Project	<b>IEEE 802.16 Broadband Wireless Access Working Group</b> < <a href="http://ieee802.org/16">http://ieee802.org/16</a> >	
Title	<b>Simple Path Management by Encapsulation in MMR system</b>	
Date Submitted	<b>2007-01-08</b>	
Source(s)	Changkyoon Kim, Kyu Ha Lee, Hyung Kee Kim Samsung Thales Co., Ltd San 12-1, Nongseo-Dong, Giheung-Gu, Yongin-City, Gyeonggi-Do, Korea 446-712	Voice: +82-31-280-9919 Fax: +82-31-280-1620 <a href="mailto:changkyoon.kim@samsung.com">changkyoon.kim@samsung.com</a>
Re:	This is a response to Call for Technical Proposals issued by IEEE 802.16j.	
Abstract	We suggest the simple path management by encapsulation in MMR system.	
Purpose	The objective of this contribution is to propose path management for MMR system.	
Notice	This document has been prepared to assist IEEE 802.16. It is offered as a basis for discussion and is not binding on the contributing individual(s) or organization(s). The material in this document is subject to change in form and content after further study. The contributor(s) reserve(s) the right to add, amend or withdraw material contained herein.

## Simple Path Management by Encapsulation in MMR System

Figure 19—Generic MAC header format

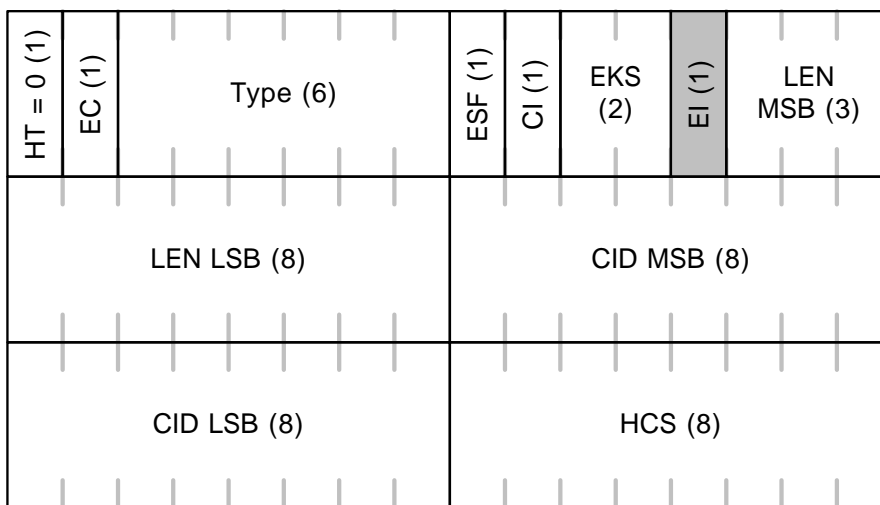
Replace Figure 19 in 6.3.2.1.1 with the following figure:
